April 18, 2023 (Revised April 27, 2023)

RE: Supplemental Information for Land Use Applications SUB322-0002/ZMA22-0001/MISC322-002/MISC222-0005

Summary of Requested Changes to the Draft Conditions of Approval

Exhibit “E”: Conditions
File MISC322-0002/ZMA22-0001/SUB322-0002/MISC222-0005

Appendix B
Villa & Mountainview

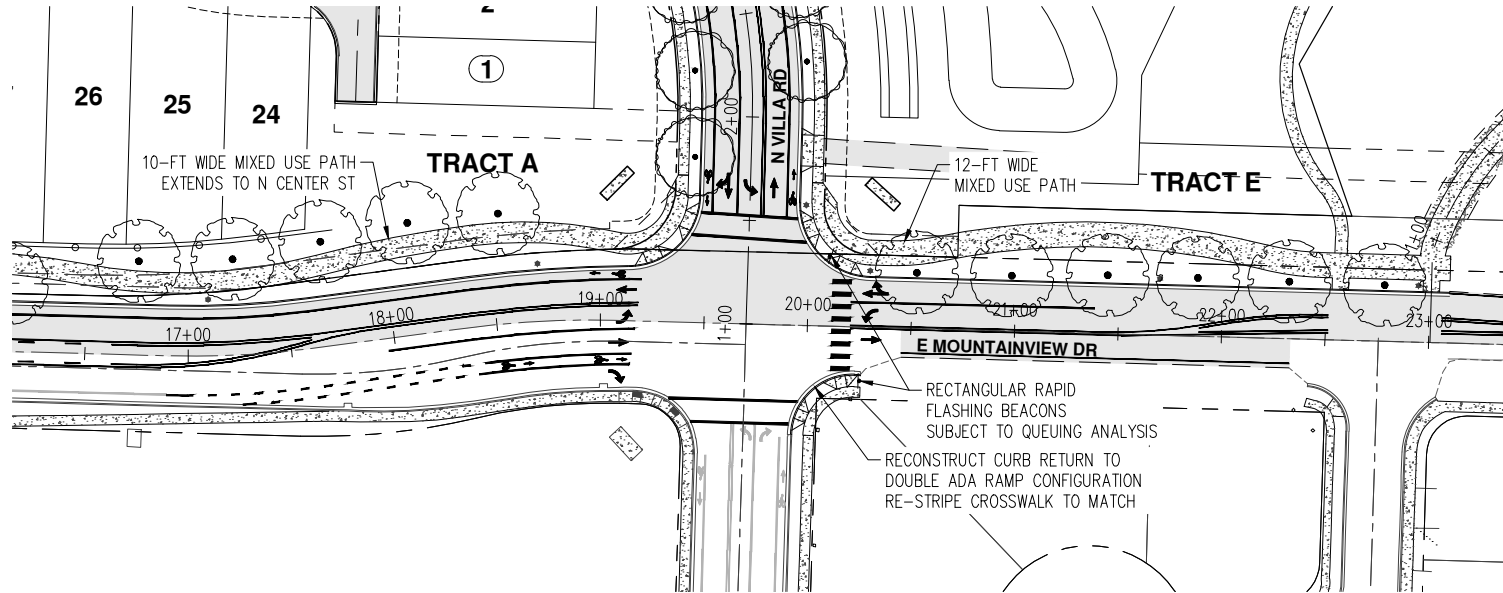
- Provide a pedestrian activated Rectangular Rapid Flashing Beacon (RRFB)⁴ on the east leg of the E Mountainview Drive/N Villa Road intersection.
- Provide marked crosswalks on the north, south and east legs of the intersection only (the east approach has a shorter pedestrian crossing distance curb-to-curb than the west approach where there is an additional right-turn vehicle lane).

- Provide a 10 – 12 foot mixed use path on the northside of E Mountainview between the N Villa Road intersection and the proposed pedestrian and bicycle bridge to the east.

- Do not mark crosswalks on E Mountainview Drive at the N Thorne Street intersection nor a direct connection to the pedestrian and bicycle bridge.
- Provide a 10 feet mixed use path to the west of the N Villa Road intersection to encourage users to remain on the north side of E Mountainview Drive between N Villa Road and N Center Street.

- Provide a second RRFB at the N Center Street/E Mountainview Drive intersection to facilitate north-south crossings of E Mountainview Drive.
- Maintain the striped on-street bike lanes on E Mountainview Drive between N Center Street and N Villa Street.

Appendix B provides a drawing prepared by AKS illustrating the above proposed safety enhancements for pedestrians and cyclists.

Figure 1: Springbrook Master Plan - Mountainview Drive

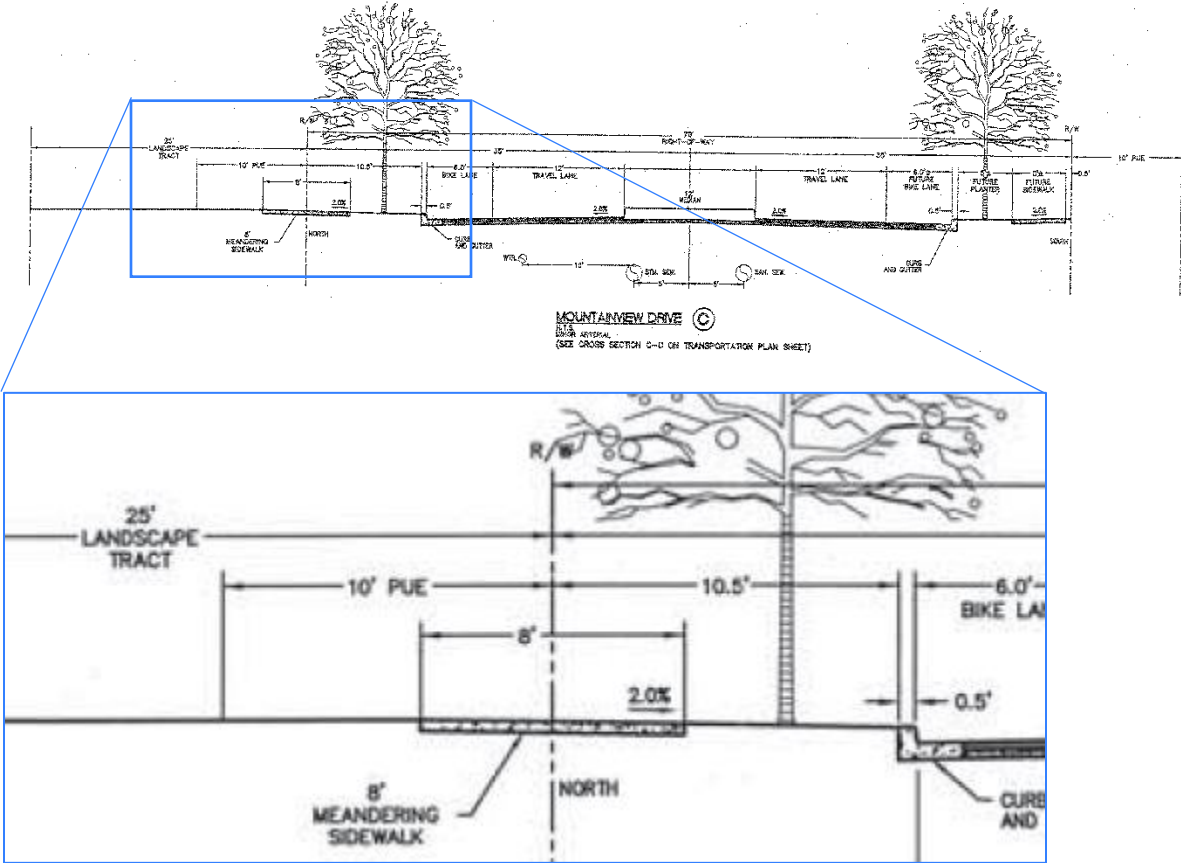
The 8-foot sidewalk is planned to meander along the northern side of E Mountainview Drive within the Landscape Tract area. A Public Access Easement will be provided. The configuration and widths proposed meet the standards contained within code and the general design contained within the Springbrook Master Plan (Figure 1) and Master Subdivision (Figure 2) approval.

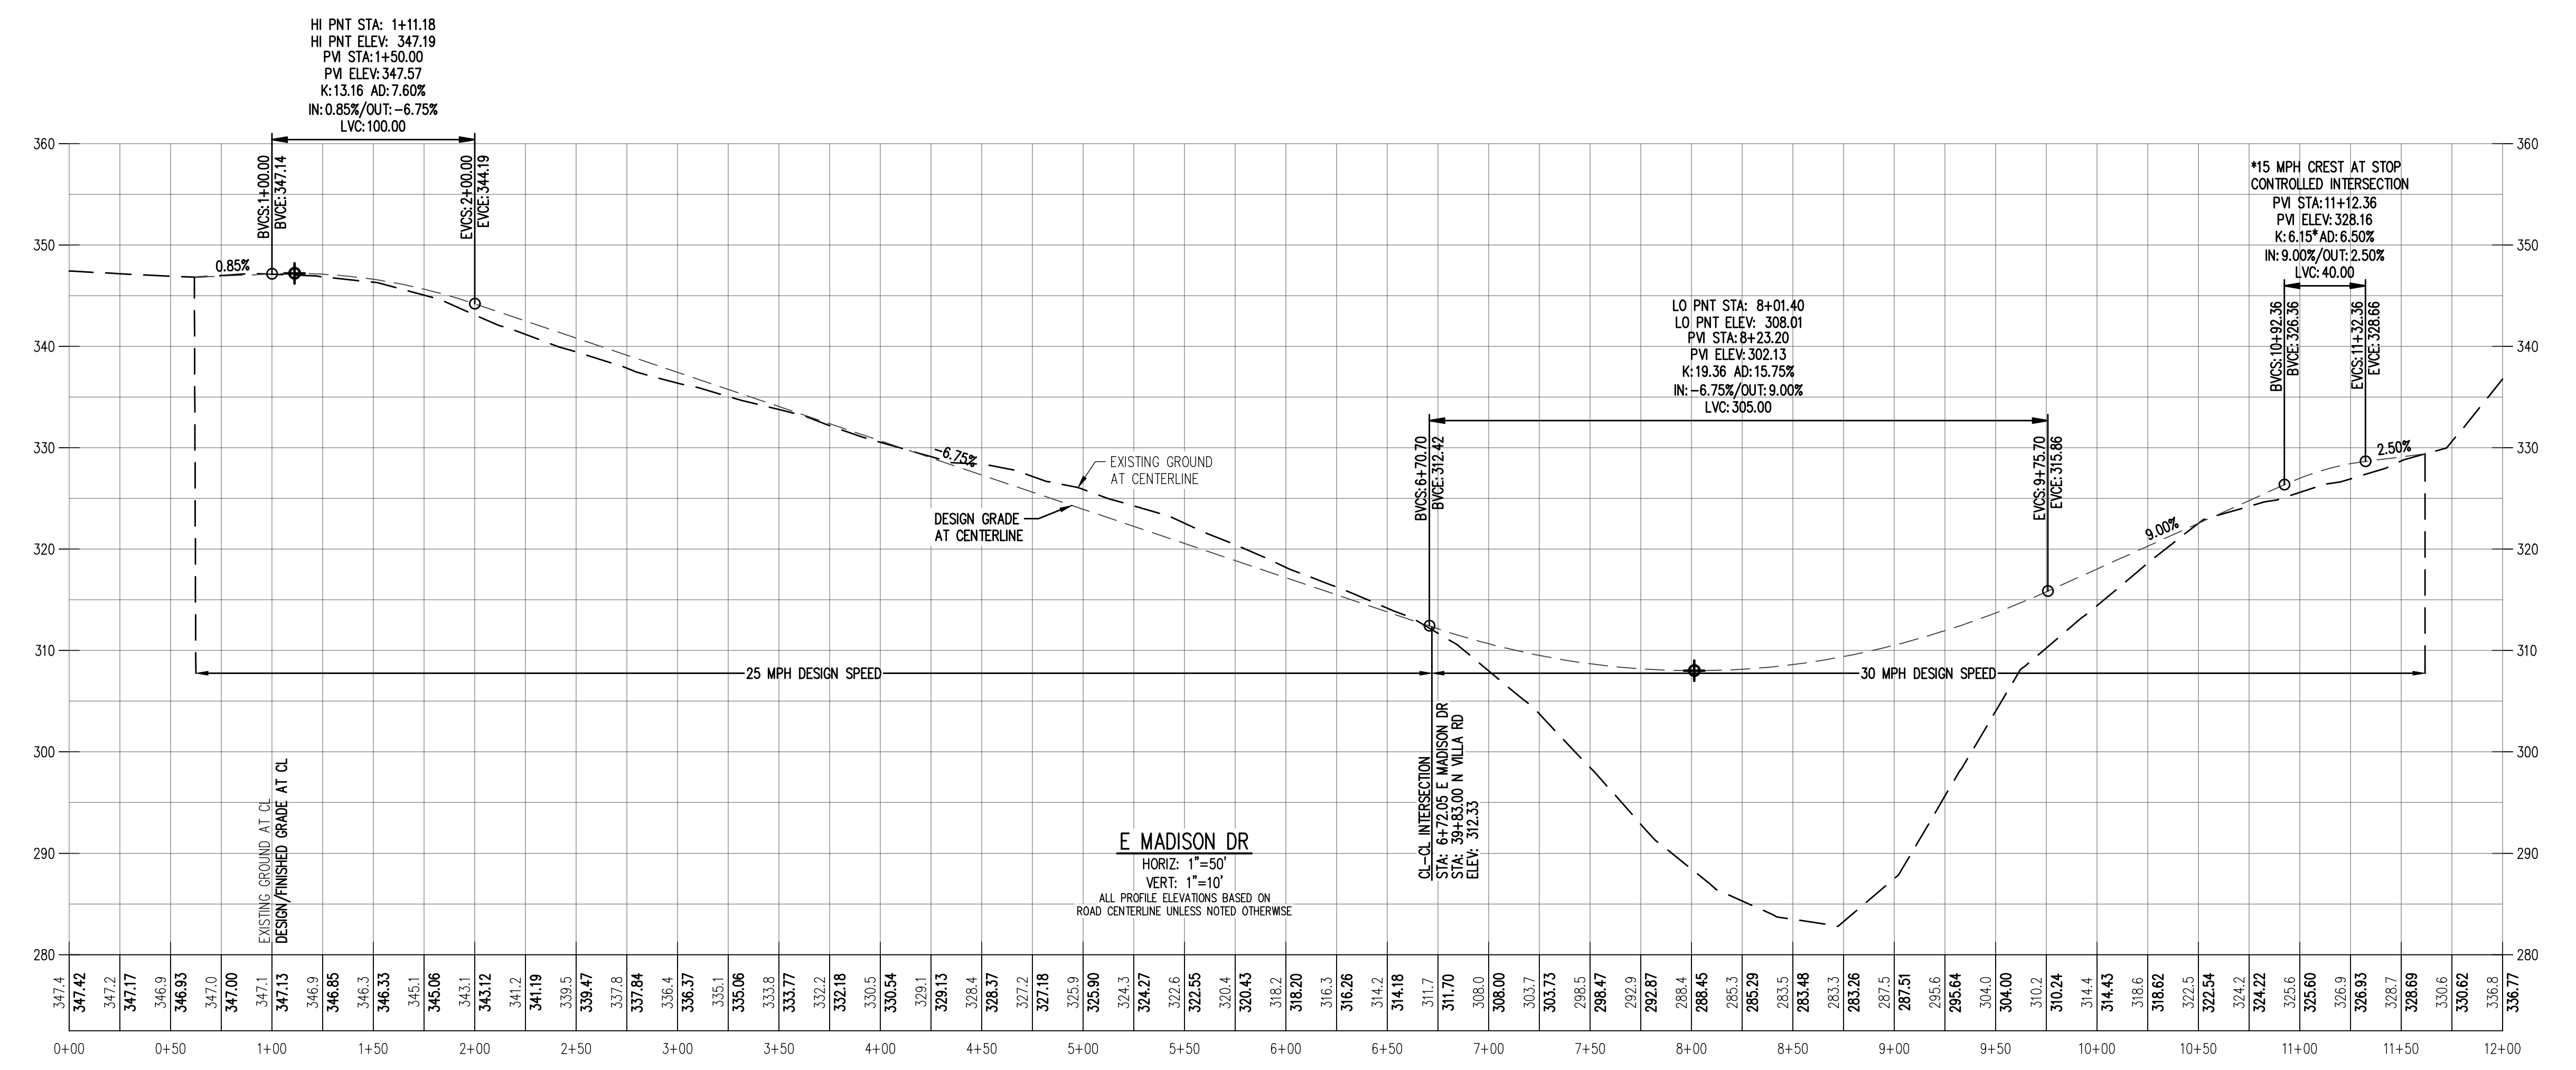
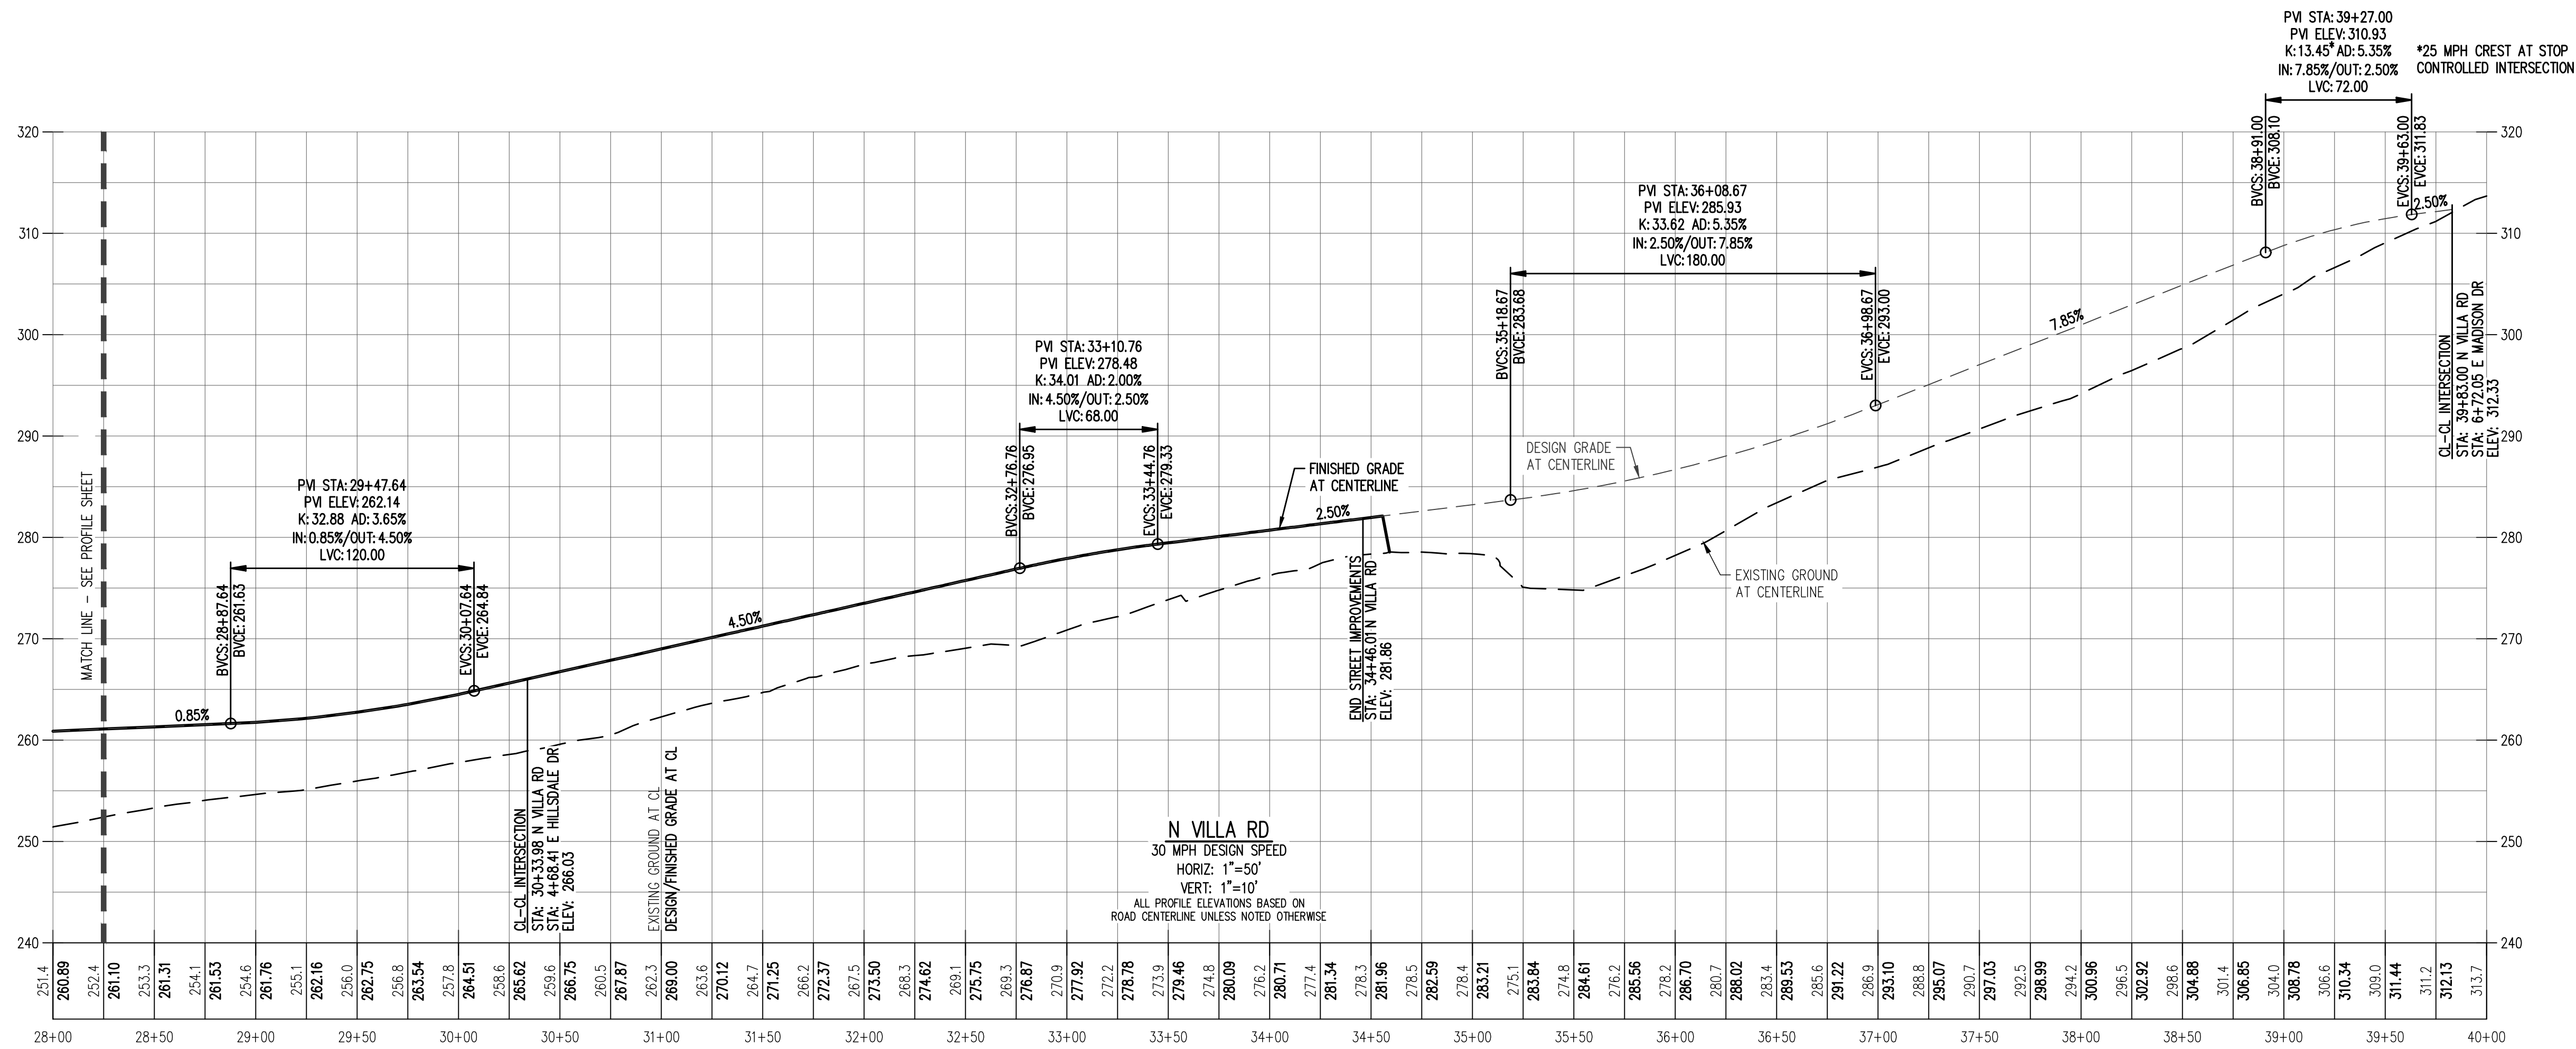
The Collina at Springbrook project includes an extension of N Villa Road to the northern extents of the project site. As part of the original Springbrook Master Plan, N Villa Road was planned to intersect N Aspen Way at the northwestern corner of the project site. Pursuing the original design of the intersection would be impractical and possibly unsafe due to the limited visibility and positioning on an existing curve. Therefore, the project team has designed N Villa Road to continue north to the adjacent property so that a safe intersection could be accomplished by a future extension of Madison Drive. The proposed layout retains the connectivity established throughout the Master Plan and does so in a more logical and safer manner.
